# UNITED STATES PATENT AND TRADEMARK OFFICE

APPLICATION NO.	FILING DATE	FIRST NAMED INVENTOR	ATTORNEY DOCKET NO.	CONFIRMATION NO.
10/535,058	05/13/2005	Herfried Karl Wieczorek	DE 020240	9416
24737	7590	08/11/2006	EXAMINER	
PHILIPS INTELLECTUAL PROPERTY & STANDARDS P.O. BOX 3001 BRIARCLIFF MANOR, NY 10510			THOMAS, COURTNEY D	
			ART UNIT	PAPER NUMBER
			2882

<b>Office Action Summary</b>	<b>Application No.</b>		<b>Applicant(s)</b>	
	10/535,058		WIECZOREK, HERFRIED KARL	
	<b>Examiner</b>		<b>Art Unit</b>	
	Courtney Thomas		2882

## DETAILED ACTION

Figure 3 – X-ray Apparatus – U.S. patent Application Publication 2001/0005409 to Gohno et al.

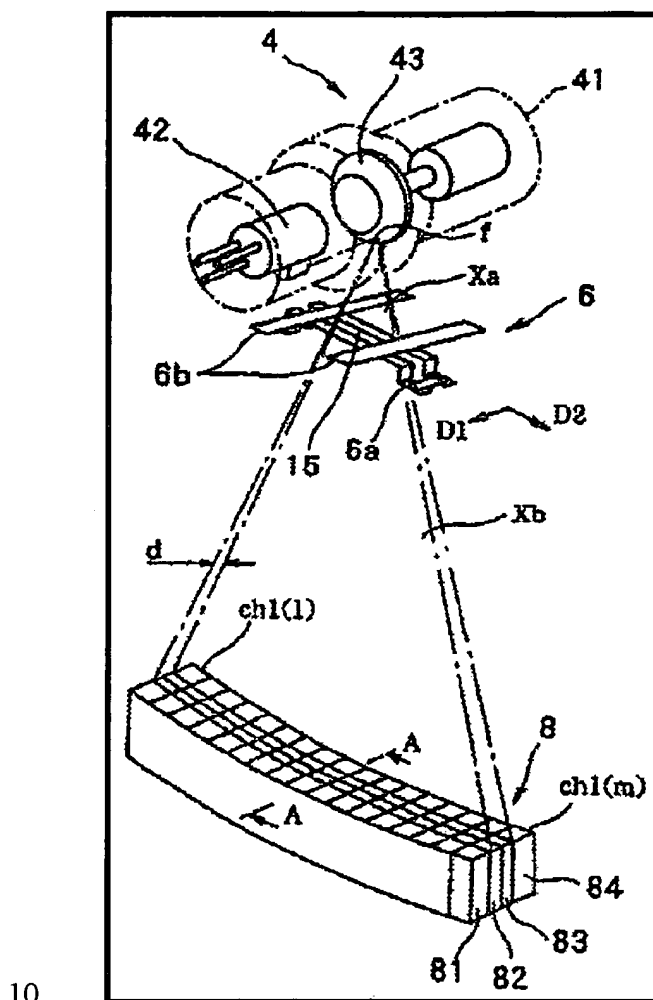
11. As per claim 1, Gohno et al. disclose an X-ray apparatus comprising an X-ray source (4) and detector (8); the detector including a photoconductor (not shown above - treated as a photosensitive element such as a photodiode), readout elements and an output circuit (see Figs. 2 & 5-7, not shown above), wherein a central group of readout elements is located in a central region (see Fig. 3 above) and a peripheral group of readout elements located in a peripheral region which surrounds the central region; the X-ray apparatus being provided with a selection

system (6) to select the central group of readout elements so as to supply pixel signals from the central group of readout elements to the output circuit.

12. **As per claim 2**, Gohn et al. disclose an X-ray apparatus wherein the selection system includes an X-ray shielding member that shields the peripheral region of the photoconductor from incident X-ray radiation (see Fig. 3 above).

13. **As per claim 3**, Gohn et al. disclose an X-ray apparatus comprising a collimator between the X-ray source (4) and x-ray detector (8), wherein the collimator comprises an X-ray absorbing member which is spatially registered with the peripheral region of the photoconductor (see Fig. 3 above).

14. **As per claim 6**, Gohn et al. disclose an X-ray apparatus wherein the selection system electrically isolates the peripheral group of readout elements from the output circuit (see Fig. 3 above).

one having ordinary skill in the art at the time the invention was made to modify the apparatus of Gohn et al. such that it incorporated electrodes of readout elements of the peripheral group being smaller sized than collecting electrodes of the readout elements of the central group. One would have been motivated to make such a modification for the purpose of enhancing signal readout of the central detection array while minimizing the influence of the shaded peripheral group as suggested by Gohn et al. (see Fig. 3 above).
